Product / Process Change Notification (PCN)

PCN #: PCN_conDSUB_20220320

Affected Series: WR-DSUB- 618025231421

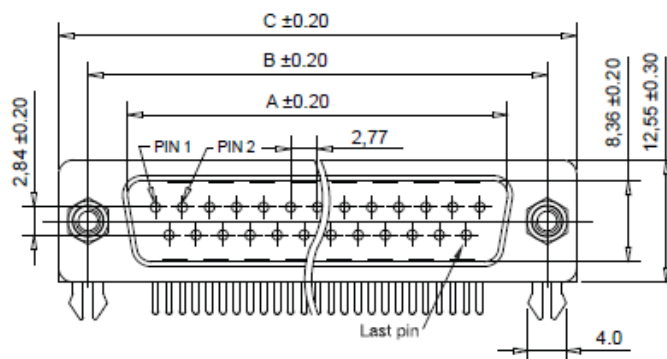
As a datasheet information amendment, Würth Elektronik will correct product dimensions A & C on the datasheet.

BEFORE	AFTER
A	39.94 mm	38.96 mm
C	53.04 mm	53.03 mm
